Subject: **SBWR Test Program**

Reference: Purdue Testing Meeting, GIRAFFE Testing Program RAIs,
October 1, 1993

Requests for Information by Purdue University prior to
meeting on October 1, 1993.

GE ANSWERS TO PURDUE UNIVERSITY QUESTIONS ON SBWR SYSTEMS

FAPCS

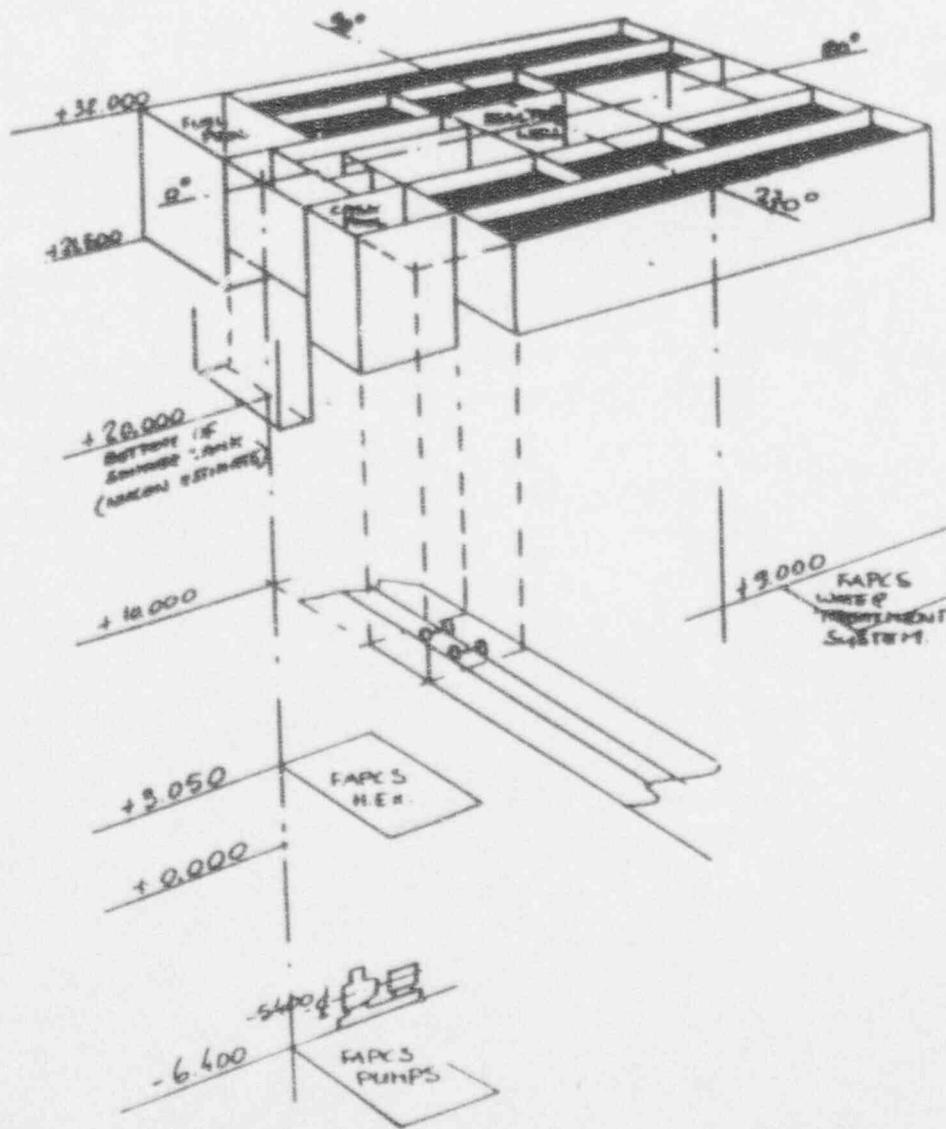
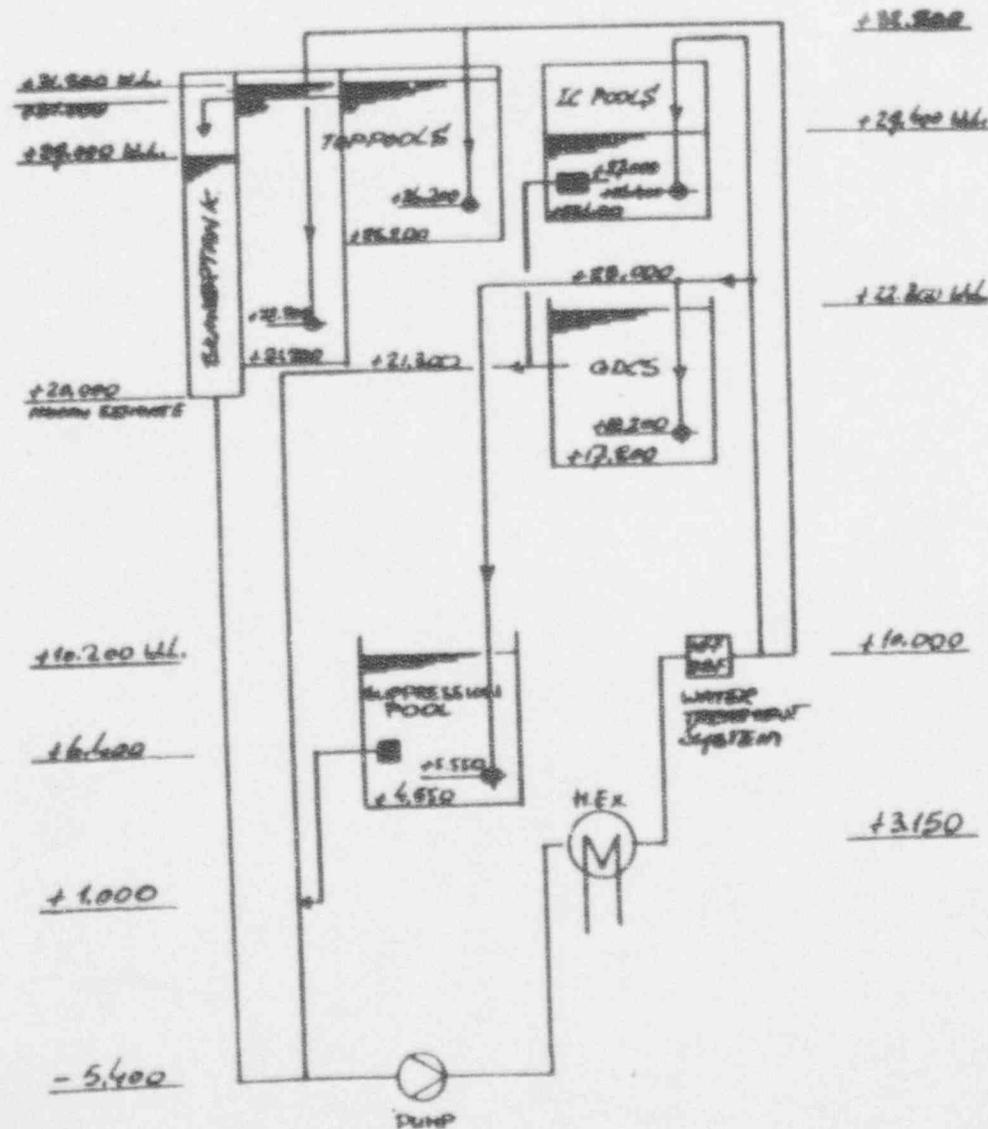
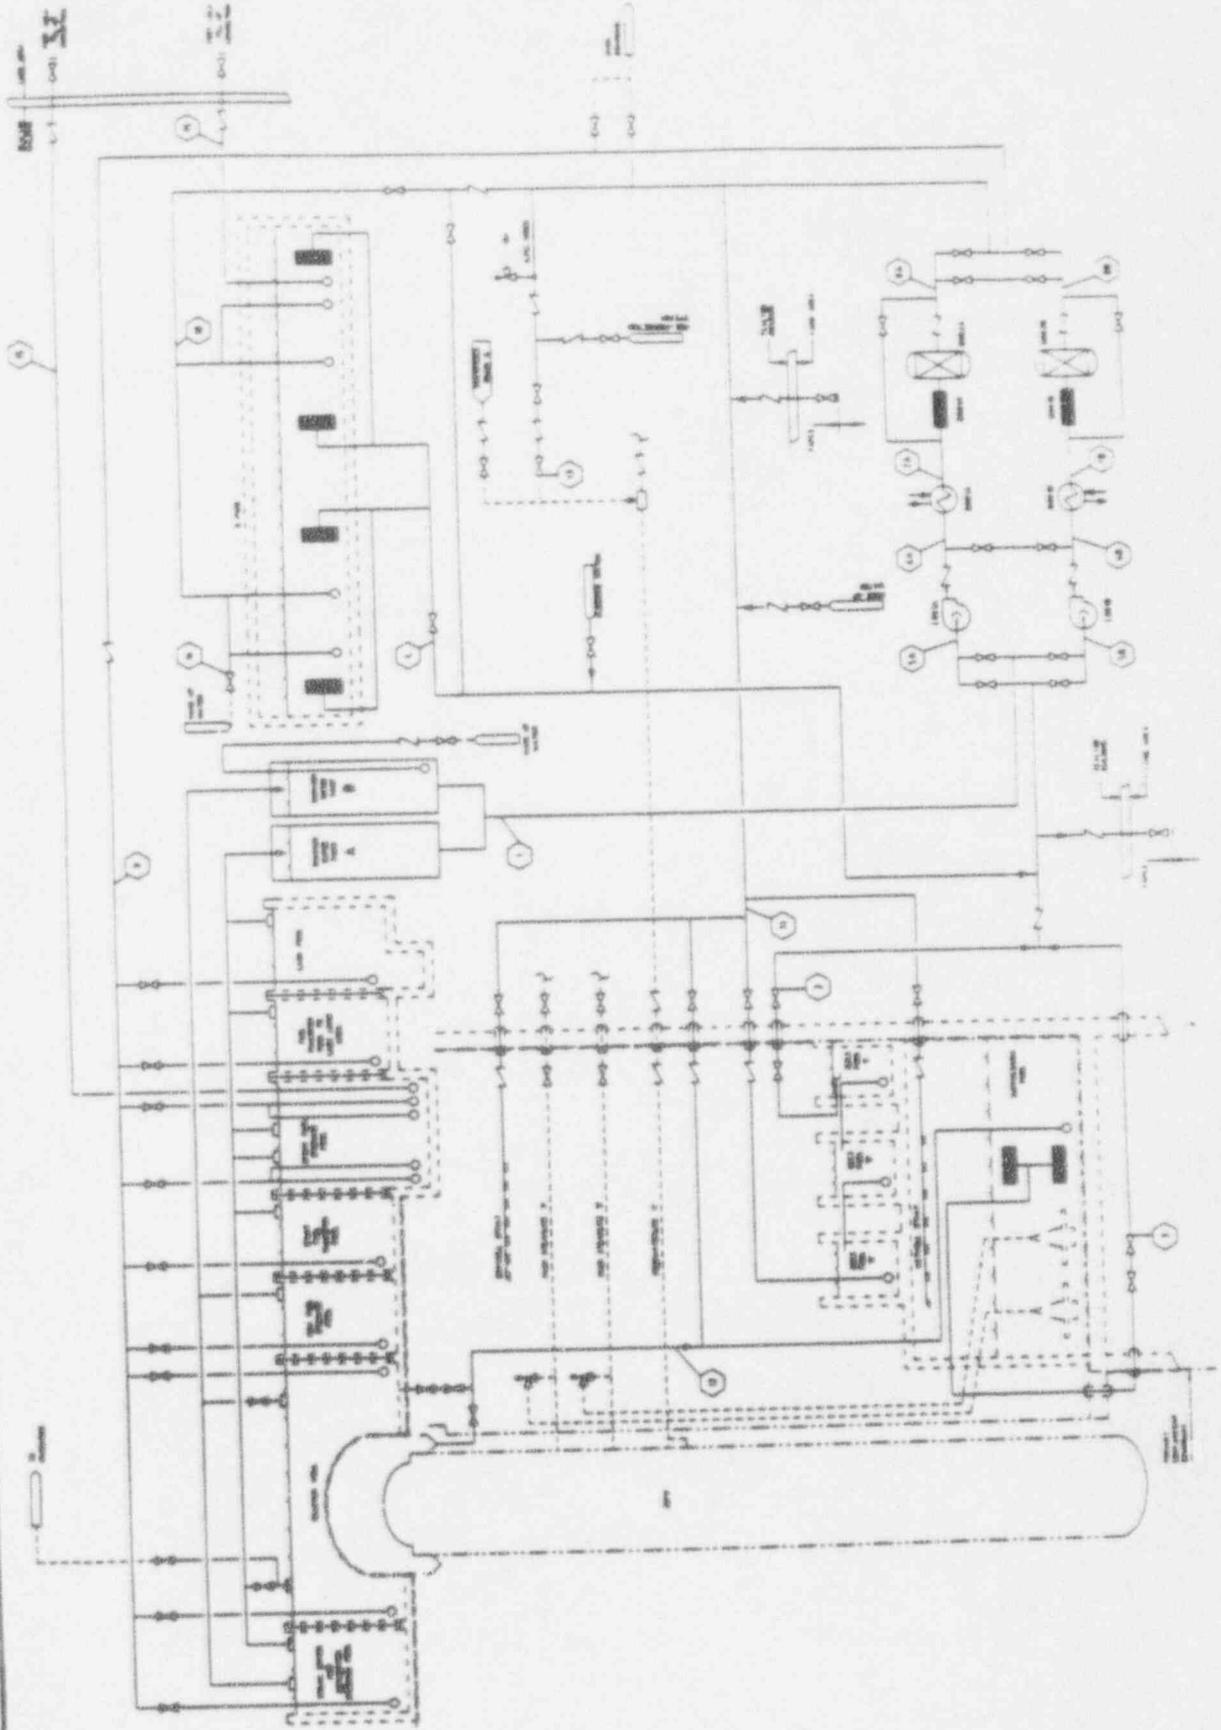
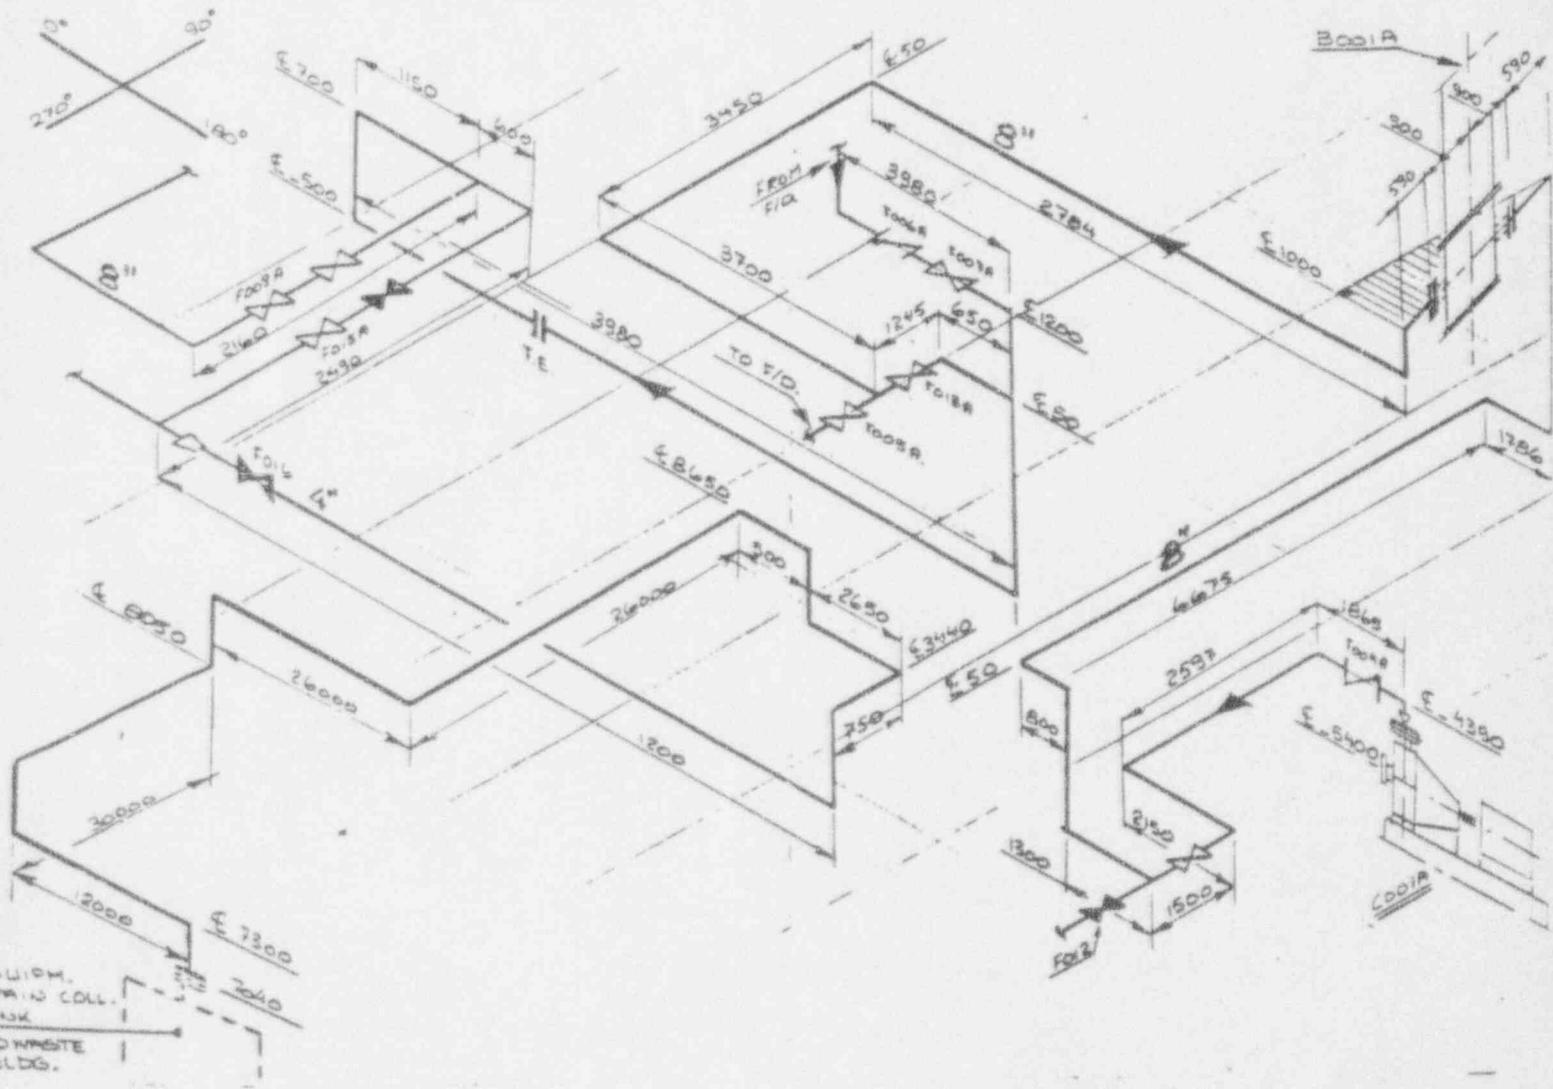
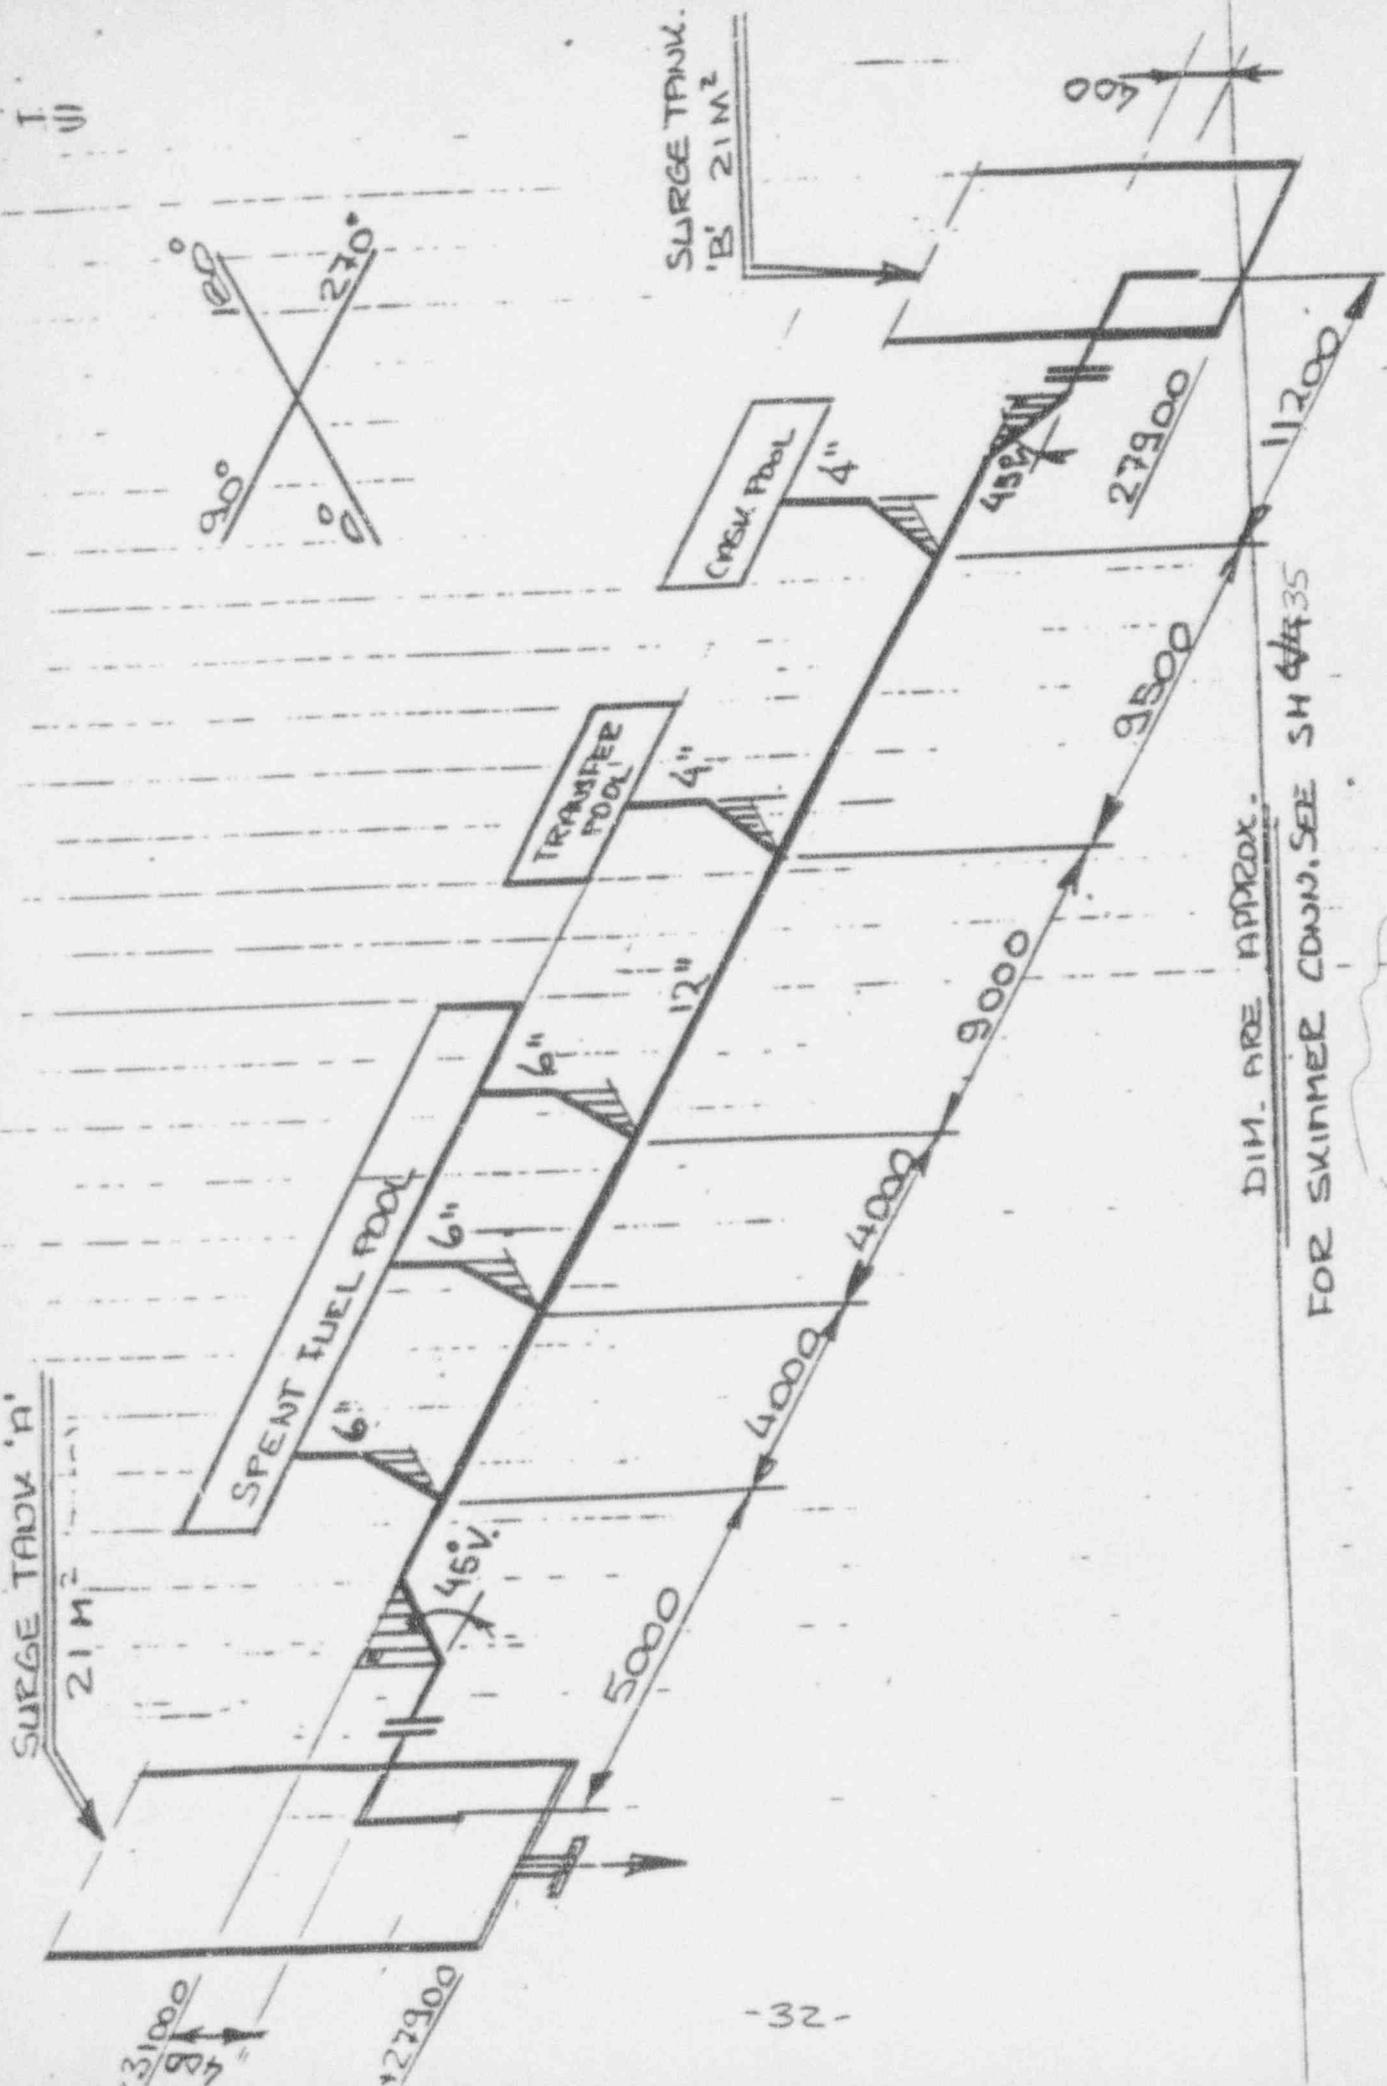
- c. Fuel and Auxiliary Pool Cooling Systems
 - d. Feed Water Lines
7. Can GE provide us with their code calculations of blowdown phase? We are interested in the thermal hydraulic parameters at about 150 sec. After MSL break, information on vessel liquid level (time dependent level due to swelling), quality, void fraction, and exact decay heat power levels will be useful.

- c. FAPCS: see attached isometric drawings (isometric drawings are only available for portions of this system).
- d. FW line: See response to question 1b.
